# Access Compliance Report

## Public Rights-of-Way

### (Curb Ramps)

Intersection ID: 10025384	Main Street: E_9TH_ST	Cross Street: N/A	Location: N
ADA ID: 1B91D89A4E7E	Ramp Type: Perp	Initial Pass/Fail: Fail	Overall Compliance: No
Severity Score: 8.75			
Codes/Mitigation Info/Possible Solution		Field Measurements/Component Compliance

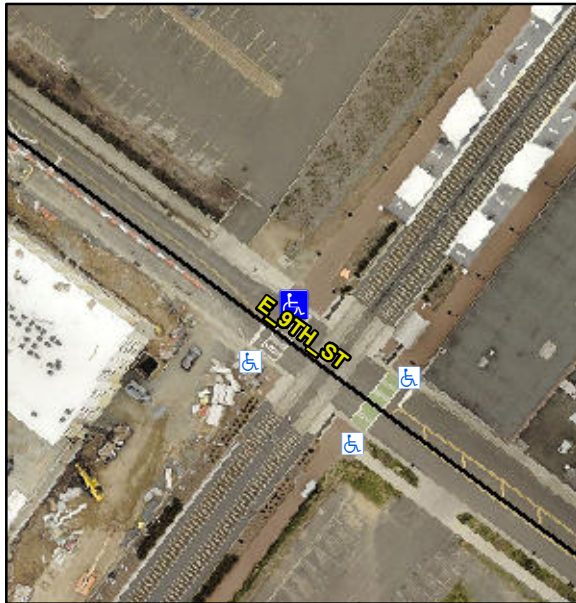
**Not Found, R304.5.1**

Compliance	Description	Data	Compliance	Description	Data
N/A	Ramp Length (in)	71.0	Yes	Ramp Slope (%)	5.2
No	Ramp Width (in)	47.5	Yes	Ramp XSlope (%)	0.2
N/A	Flare Type LT	N/A	N/A	Flare Type RT	N/A
N/A	Flare Slope LT (%)	N/A	N/A	Flare Slope RT (%)	N/A
N/A	Flare Traversable LT?	N/A	N/A	Flare Traversable RT?	N/A
N/A	Landing Length (in)	N/A	N/A	DWS Provided?	N/A
N/A	Landing Width (in)	N/A	N/A	DWS Contrast?	N/A
N/A	Landing Slope (%)	N/A	N/A	DWS Length (in)	N/A
N/A	Landing X Slope (%)	N/A	N/A	DWS Full Width?	N/A
N/A	Landing Curb? (Y/N)	N/A	N/A	DWS Offset (in)	N/A
N/A	Shared Landing?	N/A			
N/A	Gutter Ponding?	N/A	N/A	Gutter Slope (%)	N/A
N/A	Gutter Lip Ht (in)	N/A	N/A	Gutter X Slope (%)	N/A
N/A	Painted X Walk1?	No	N/A	Painted X Walk2?	N/A
	X Walk 1 Direction	To SW		X Walk 2 Direction	N/A
N/A	X Walk 1 Width (in)	N/A	N/A	X Walk 2 Width (in)	N/A
	X Walk 1 Slope (%)	2.9		X Walk 2 Slope (%)	N/A
	X Walk 1 X Slope (%)	1.5		X Walk 2 X Slope (%)	N/A

**Remove & Replace Entire Ramp.**
